Technical Service Information

THM 4L60-E SOFT 1-2 SHIFT, 1994 MODELS

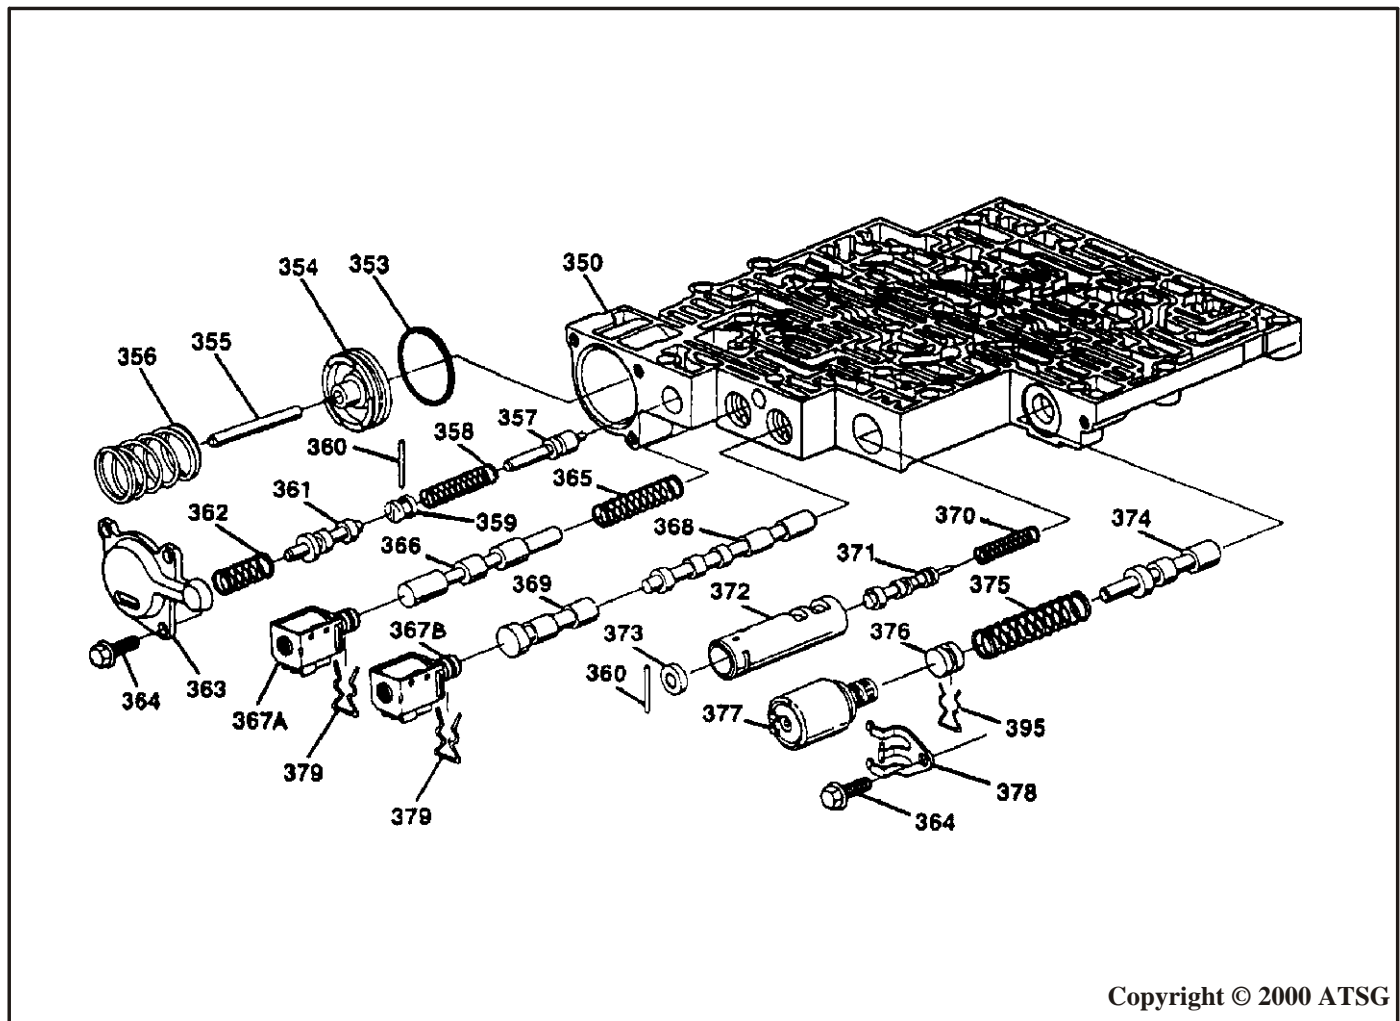
There is now available a new calibration service package consisting of a 1-2 accumulator valve, valve spring, and 1-2 accumulator valve bushing for the valve body. These are items 370, 371, and 372, as shown in Figure 1 below. This new service package is available under OEM part number 24202698.

1-2 Accumulator Valve Service Package 24202698

Figure 2

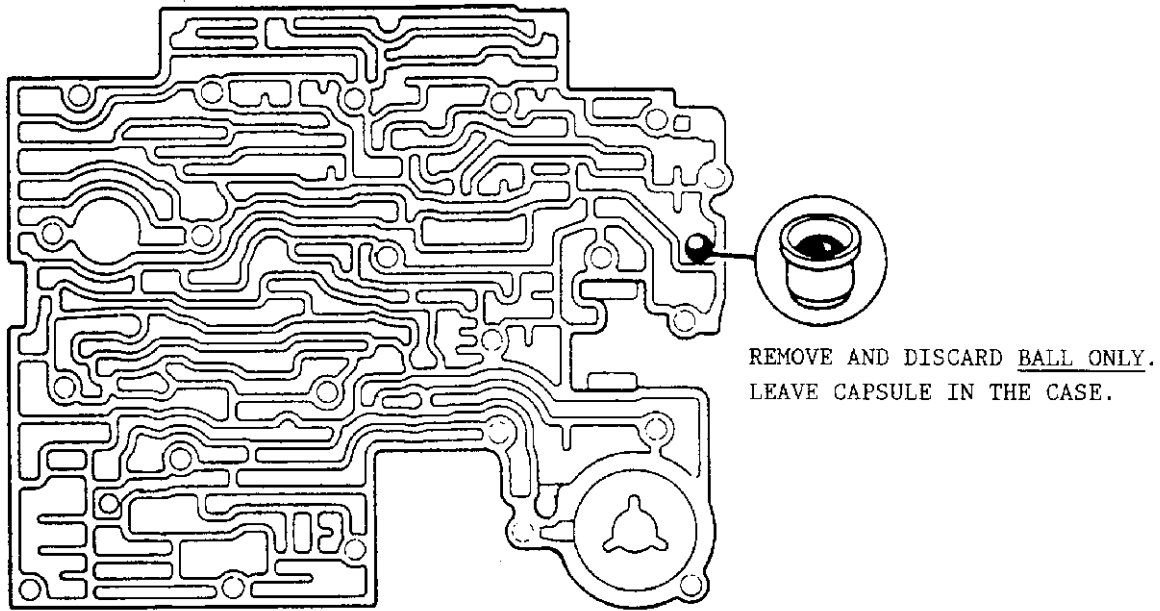
REASON: The cause may be, calibration of the 1-2 accumulator valve in the valve body.
